From: Patrick Meehan
Sent: 14/09/2023 11:42:57 PM
To: Council Northernbeaches Mailbox
Subject: TRIMMED: DA2022/2134
Attachments: DA Submission MOD2023-0460 & DA2022-2134.pdf;

MOD2023/0460 & DA2022/2134 25 OSBORNE ROAD, MANLY, 2095

We refer to the above development application (DA) and associated modification application (MODA) in respect of 25 Osborne Road, Manly, 2095 (House).

3 (A) Areas of Unit likely impacted by addition to House

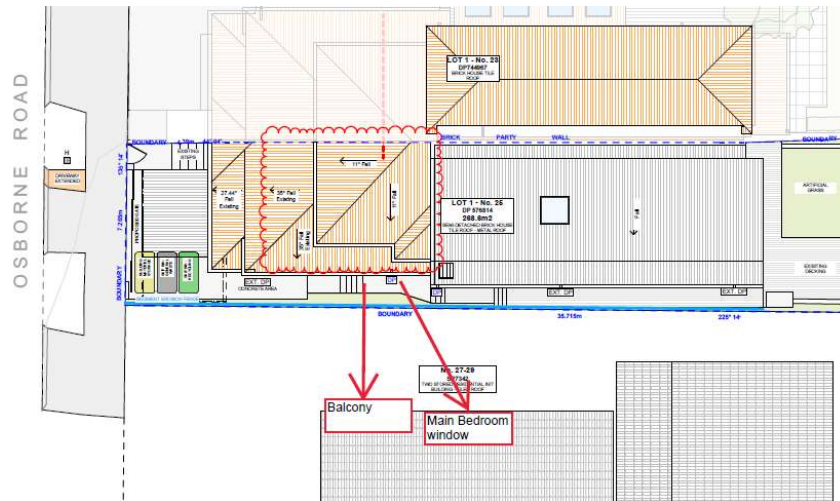
Based on page 20 of the Revised Plans, the development will introduce three additional windows to the House which will directly overlook our balcony and main bedroom window.

- further information to be provided in relation to the anticipated vertical overshadowing caused by proposed extension so that the impacts of the development on our Unit can be cross-checked against the requirements in the Manly DCP;
- further information in relation to the window design including the appropriateness of the introduction of three additional windows which will face and look into the Unit balcony, living room and main bedroom; and

Description: Red arrows shows Unit one balcony and main bedroom window with respect to the proposed development. Image taken from page 5 of the Revised Plans submitted as part of the DA.

(B) Overshadowing Diagram 1

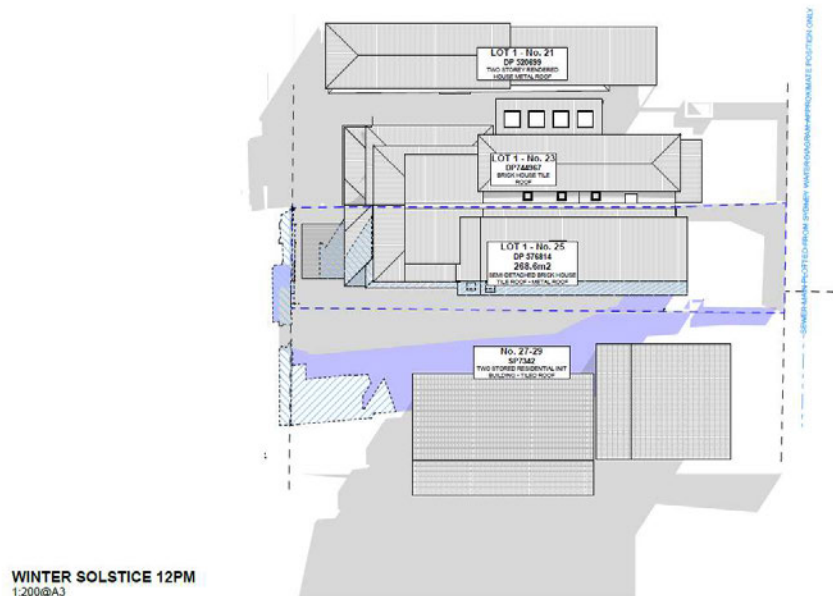
The overshadowing diagram contained on page 17 of Revised Plans fails to depict the vertical shadow encroachment during the winter solstice between 12 to 3pm that would directly impact our Unit situated on level one of the apartment building. The diagram shows the existing shadows may touch the base of our apartment block, but it does not demonstrate any further vertical shadow encroachment caused by the proposed extension (refer images at Item 3 (A), (B), (C) and (D) of the Schedule to this submission).

Description: Image shows existing and proposed shadows at 12pm on winter solstice taken from page 17 of the Revised Plans submitted as part of the DA.

(C) Overshadowing Diagram 2

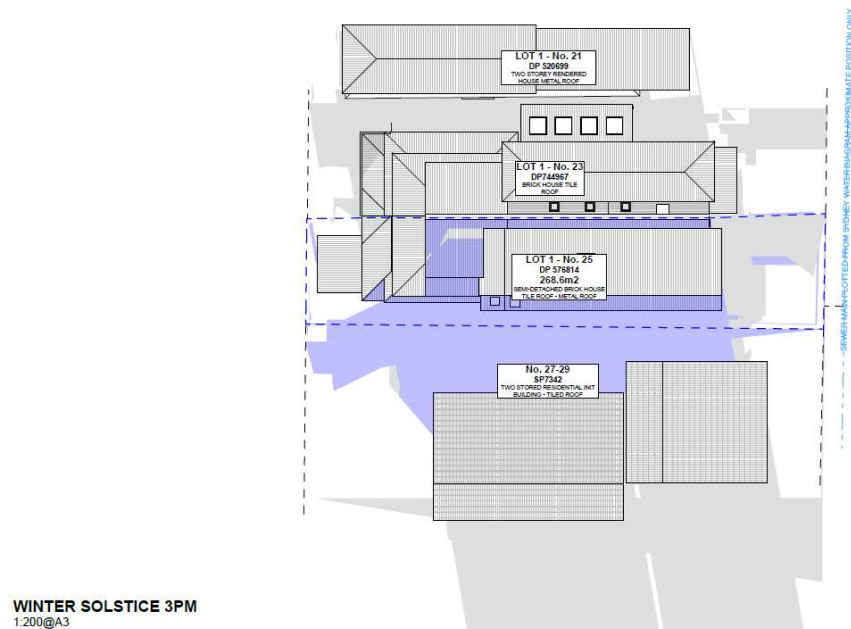
Currently, in winter, the sun is only just visible above the roof of the House when viewed from the balcony of our Unit. We believe that the DA for 25 Osborne Road is likely to entirely block the sun that hits our balcony and living room in the afternoon.

Description: Image shows existing and proposed shadows at 3pm on winter solstice taken from page 18 of the Revised Plans submitted as part of the DA.

Figure 10 .

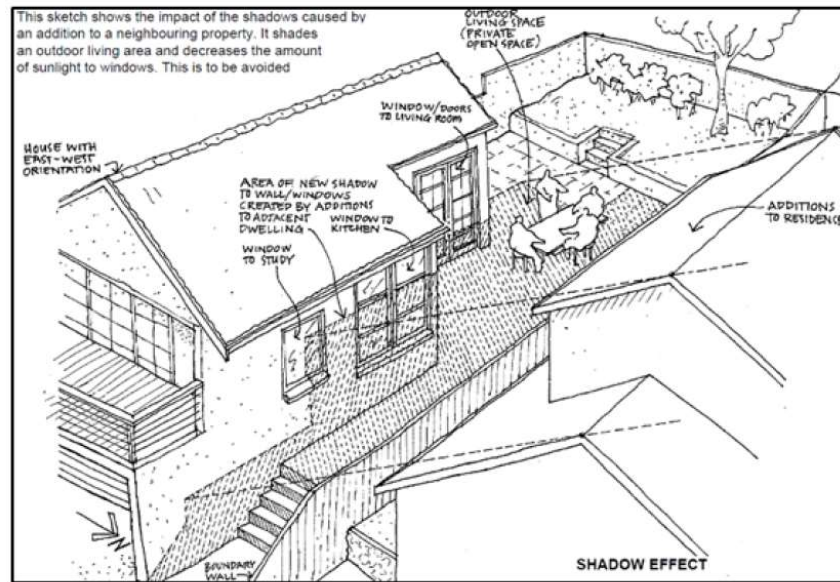
Description: Image extracted from the Manly DCP at section 3.4.1.2. Notation in left hand column indicates that this overshadowing “should be avoided”. It is noted the house in the example from the Manly DCP is North-Westerly facing. This is the exact same scenario as our Unit 1, 27-29 Osborne St.
